Proposed Front Elevation [North]  
Scale 1:50

STATUS	
BUILDING CONTROL	
CLIENT	
Mr Jason Yu	
PROJECT	
Proposed works to 59 Cliff Road Nottingham, NG1 1GT	
TITLE	
Proposed Elevations - Sheet 2of2	
SCALE	DRAWN BY
1:50 @ A1	EC
DRAWING NUMBER	REV
21,014-B-207	E
DISCLAIMER	
This drawing is Copyright of Wilson Architects Ltd. This drawing not to be used other than the purpose for which it was prepared and is to be read in conjunction with all other project documentation. All dimensions are to be checked onsite by the Main Contractor prior to work commencing. The Architect is to be informed immediately of any discrepancies and where in doubt - ask.

Proposed Side Elevation [West]  
Scale 1:50

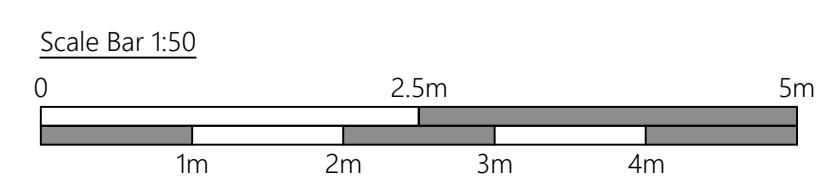
Does not reflect floor plans
